DATE:	October 16, 2026
MAI NO.:	24042
OPSC APPL. NO.:	
DSA APPL. NO.:	02-123774
DSA FILE NO.:	10-126

NEW TEMPERANCE ELEMENTARY SCHOOL

SANGER UNIFIED SCHOOL DISTRICT
SANGER, FRESNO COUNTY, CALIFORNIA

ADDENDUM NO. 3

E9.1R

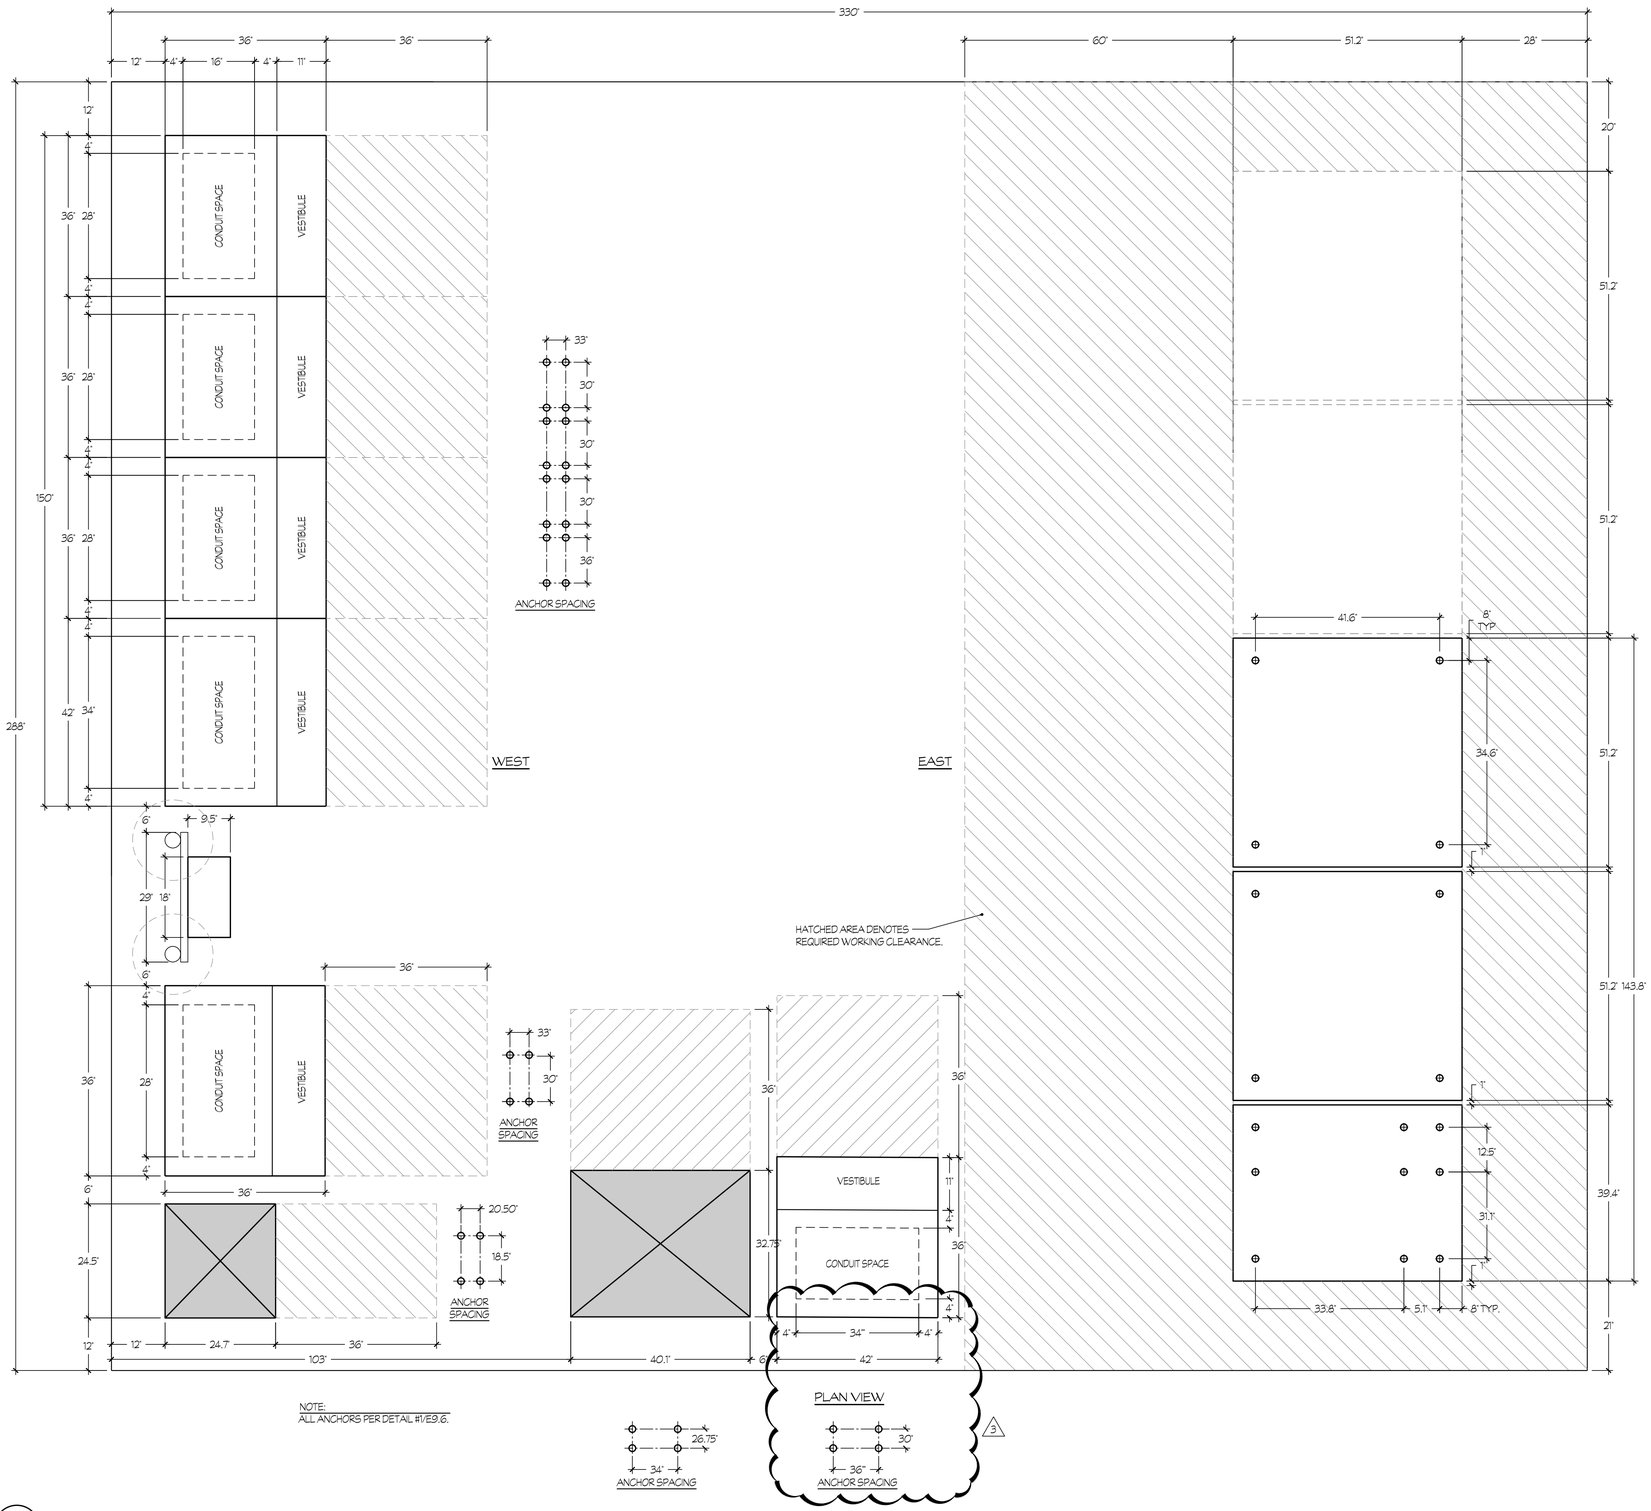
Item 4, Sheet #E9.1R:
A. See revised feeder to Panel "EV".
B. See revised utility connections to add Bus Duct secondary and primary information.
C. New information at Main Service.

E9.5R

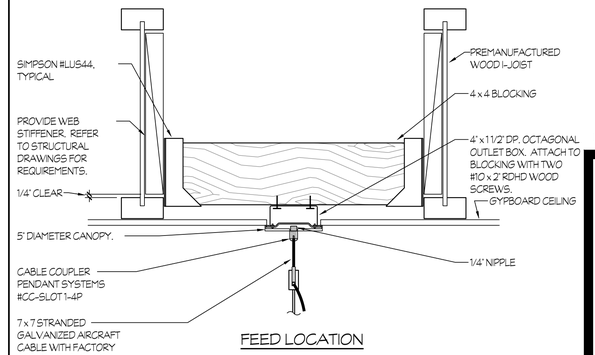
Item #5, Sheet #E9.5R:
A. See revised distribution Panel "EV" dimensions.

F3.00

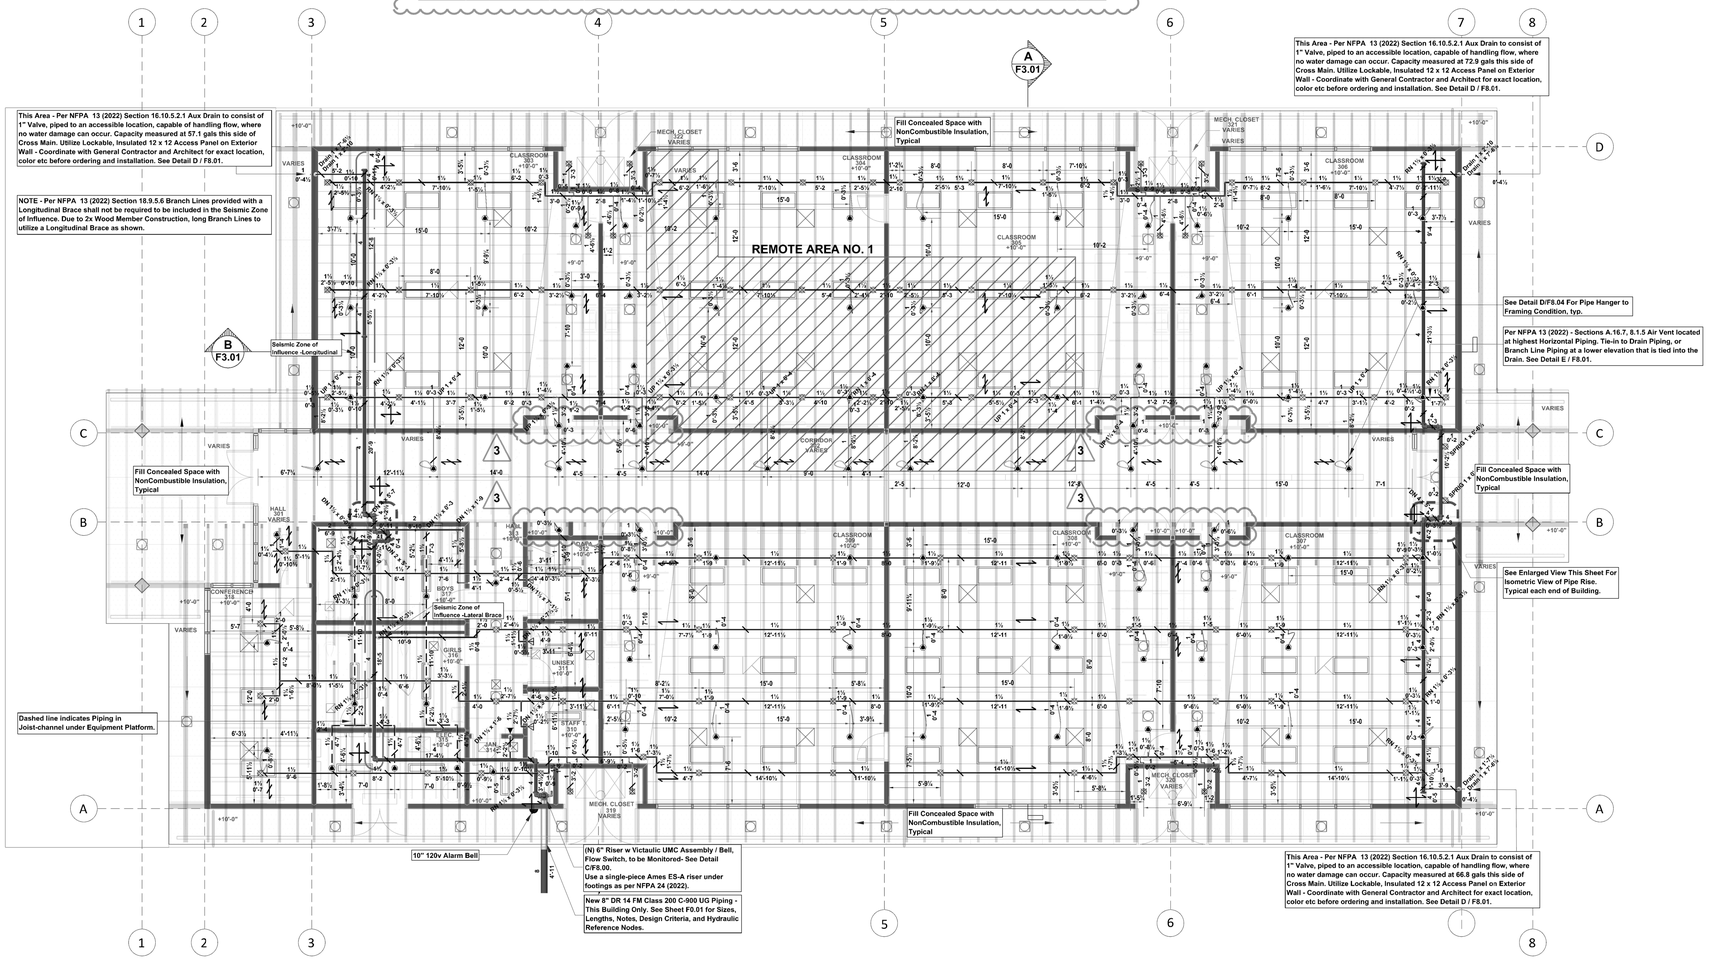
1. Sheet F3.00, "Building 300 Fire Protection Piping Plan":
    1.1. **REPLACE** sheet F.300 with the F3.00 sheet attached to this letter.
        1.1.1. A total of (8) Pendent Sprinklers to (4) small Alcoves were added in Hallway 302.

(A) SECTION - BLDGS 300-500

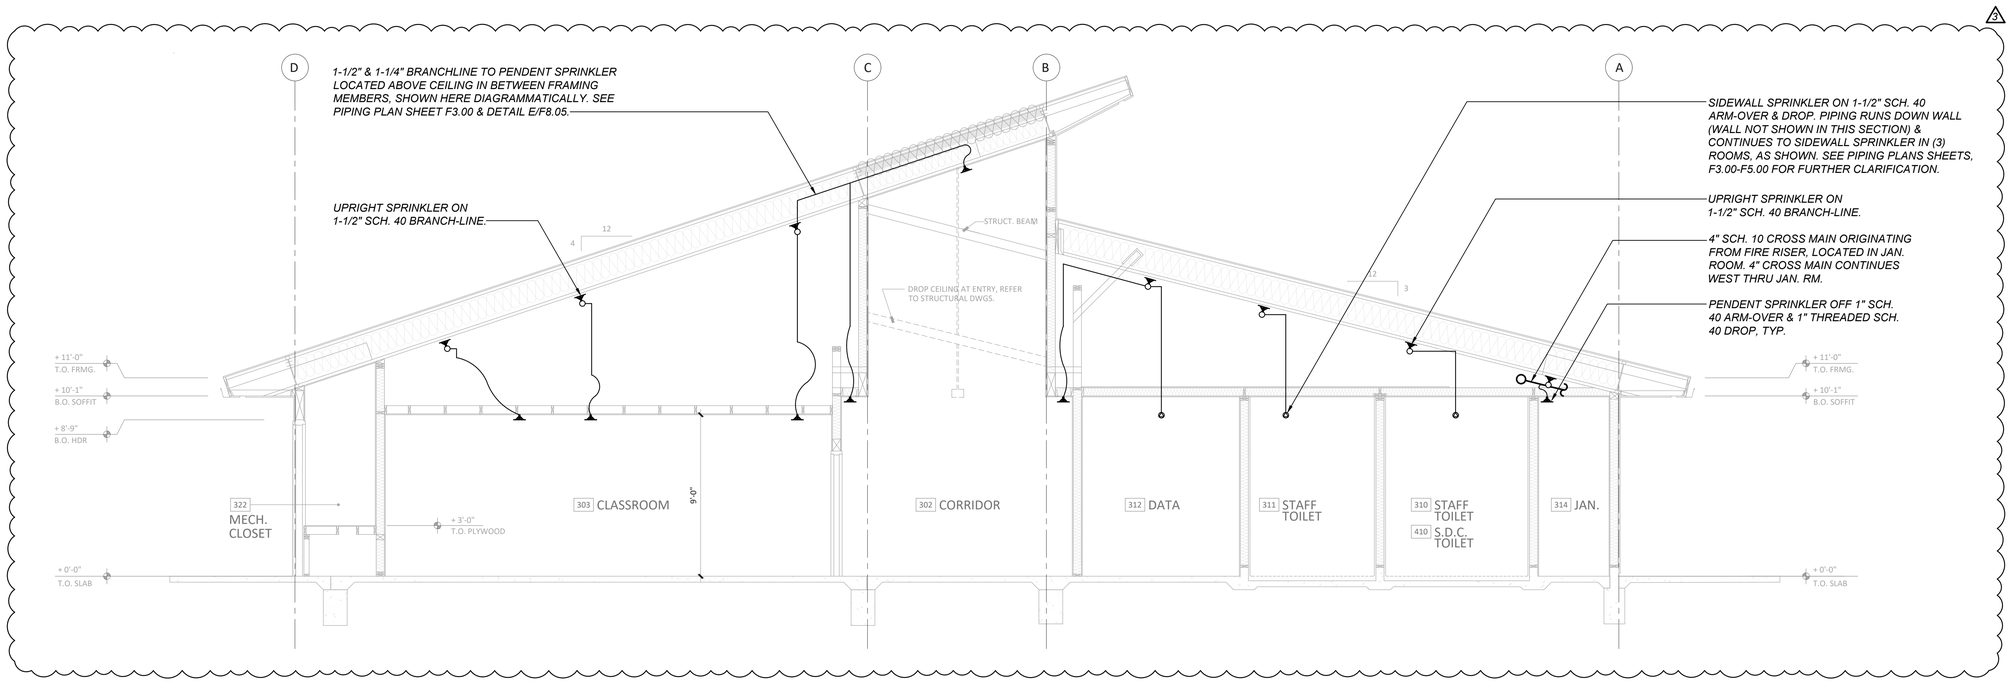
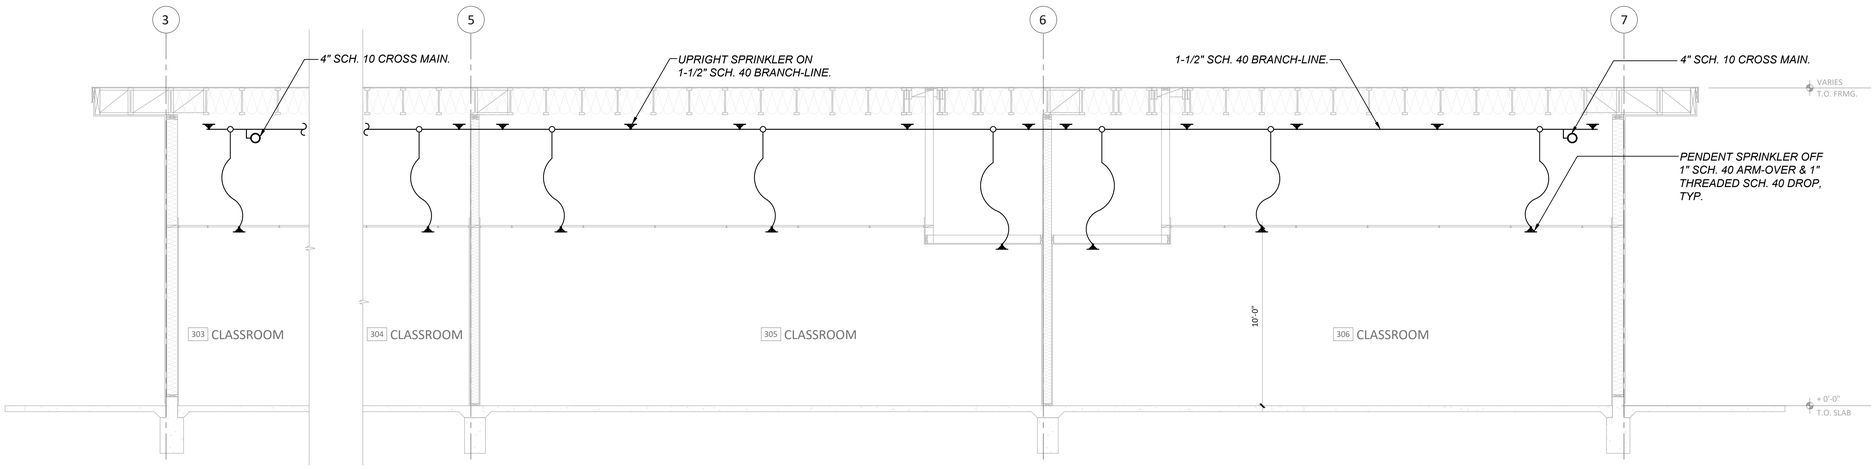
2. Sheet F3.01, "Fire Protection Piping Sections Buildings 300-500":
    2.1. **REPLACE** sheet F3.01 with F3.01 sheet attached to this letter.
        2.1.1. Section A Revised to reflect additional Sprinklers in Hallways, as reflected upon Sheets F3.00, F4.00, and F5.00

F4.00

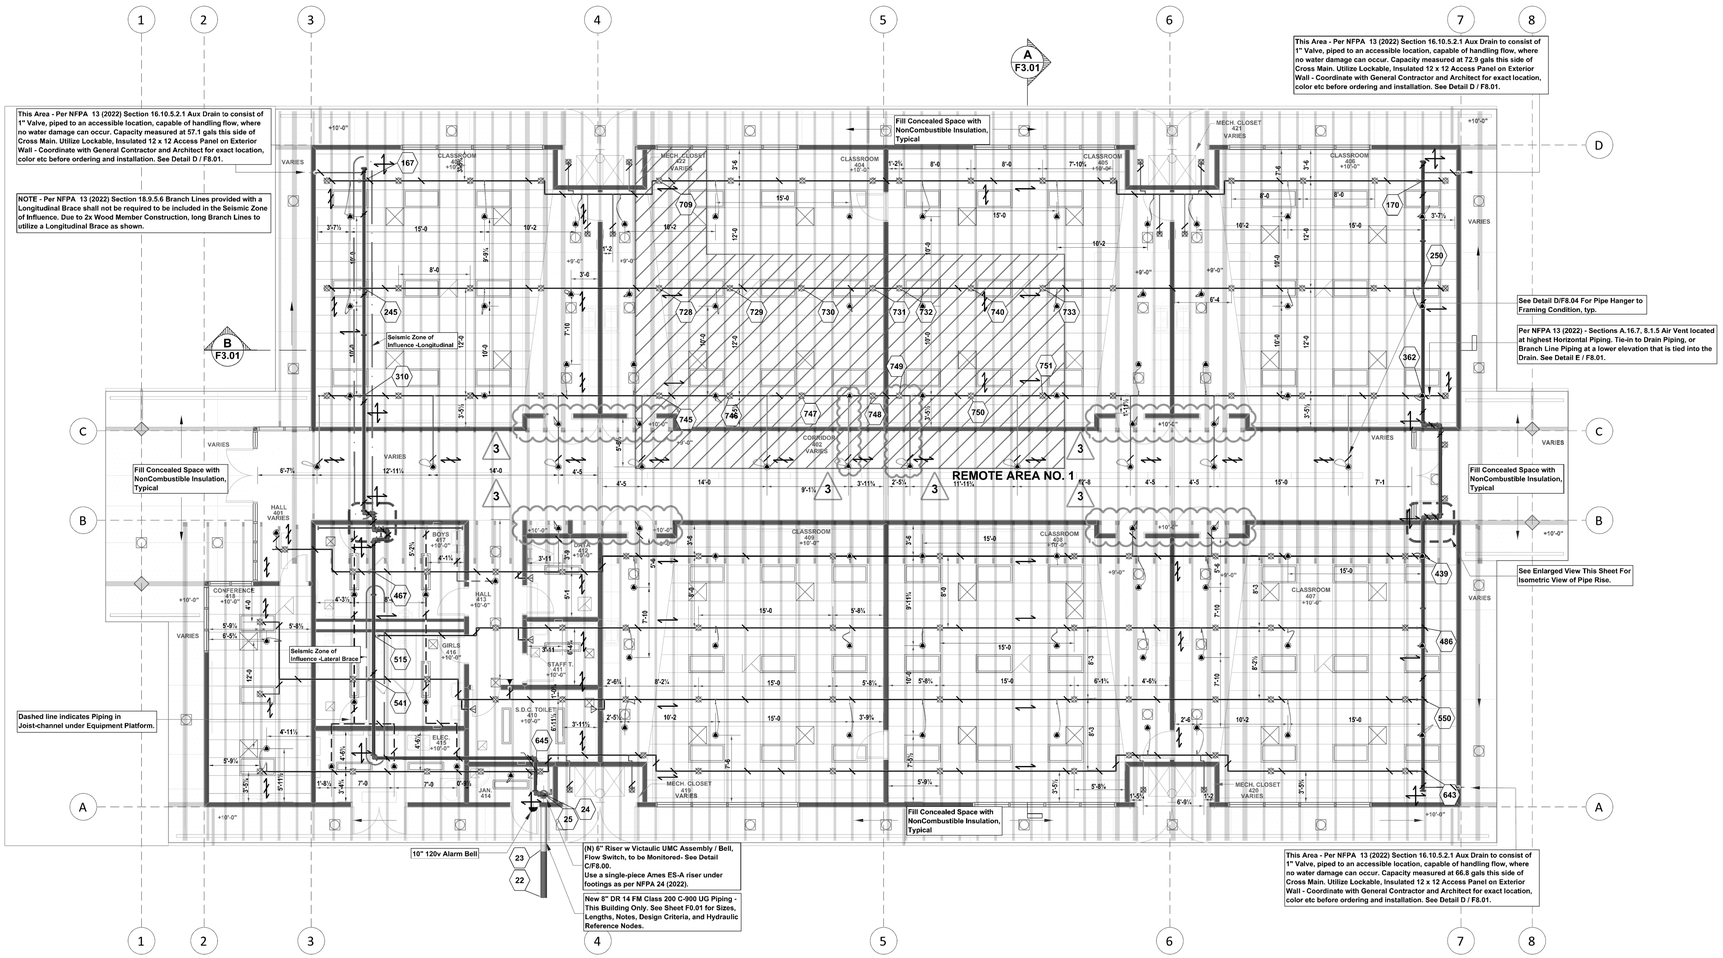
3. Sheet F4.00, "Building 400 Fire Protection Piping Plan":
    3.1. **REPLACE** sheet F4.00 with the F4.00 sheet attached to this letter.
        3.1.1. A total of (8) Pendent Sprinklers to (4) small Alcoves were added in Hallway 402.

3.1.2. Relocated (4) Armovers w/ Pendent Sprinklers, and added (1) additional Pendent Sprinkler in Hallway 402.
4. Sheet F5.00, "Building 500 Fire Protection Piping Plan":
